RS-09-043

Braidwood Station, Units 1 and 2  
Facility Operating License Nos. NPF-72 and NPF-77  
NRC Docket Nos. 50-456 and 50-457

Subject: Additional Information Supporting Braidwood I3R-04, Request for Relief from 10 CFR 50.55a(g)(6)(ii)(E), Reactor Coolant Pressure Boundary Examination Scheduling Requirements in accordance with 10 CFR 50.55a(a)(3)(i)

**ATTACHMENT**  
**Relief Request I3R-04 Response to Request for Additional Information**

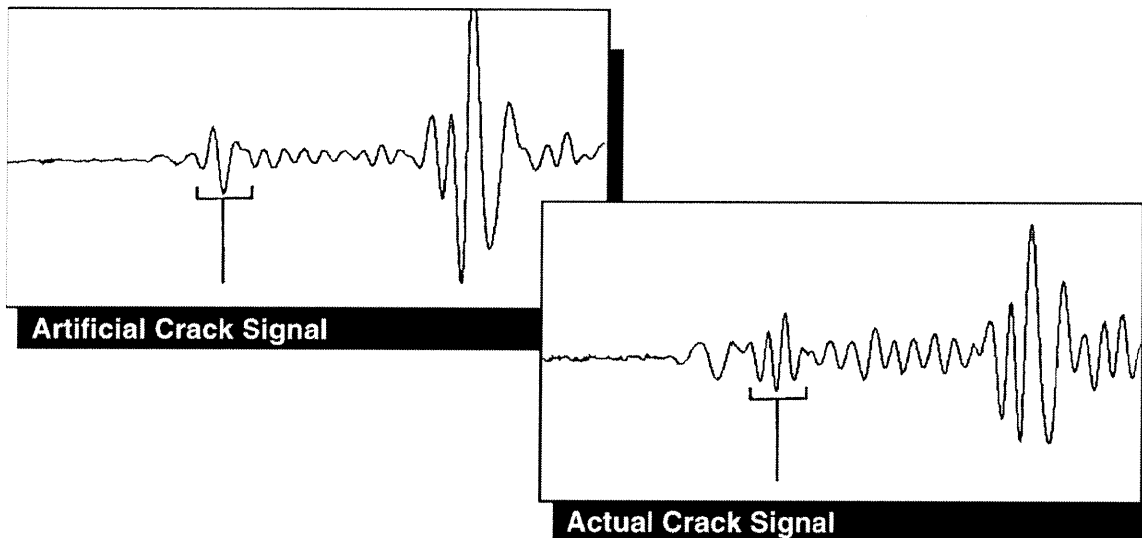
- a) Please characterize the flaw population distribution for the mockups (i.e., range of flaw length and depth, orientation, and types)?
- b) What types of implants were used to generate flaws?

- c) If cold isostatic processing (CIP) flaws were used in the mockups, please provide information on the degree of squeezing during the CIP process and whether the squeezed notches are representative of SCC. Please provide the radius of the CIP flaw tips or a direct comparison with flaws used by Performance Demonstration Initiative in Appendix VIII qualifications, and any reports that compare the response of the flaws used in the mockups with the responses from SCCs.
- d) Did the mockups have any flaws that are representative of fabrication defects? Please provide information on how the UT examiners know the difference between indications from a service induced defect and a fabrication defect.
- e) Do the mockups include a lack of fusion at the weld/tube interface?

- a. Most of these mockups are still considered blind so the flaw distributions cannot be provided in these responses. The mockups are full-scale with as-built weld geometries and have realistic distortion as caused by the J-groove weld. The flaws range in depth, length, and orientation. The mockups used for the capability study have more than 30 realistic flaws implanted in them, as documented in References 1 and 2.
- b. The implants are cold isostatic press (CIP) squeezed EDM notches in the tube.
- c. Typically the radius of the squeezed CIP notch tips used in CRDM and BMI flawed mockups are 10 microns, which is smaller than that required by ASME Section XI, Appendix VIII. Additionally, the ultrasonic notch responses have been compared to a primary water stress corrosion cracking (PWSCC) flaw at the Bugey plant, as shown in the figures below and documented in Reference 1.
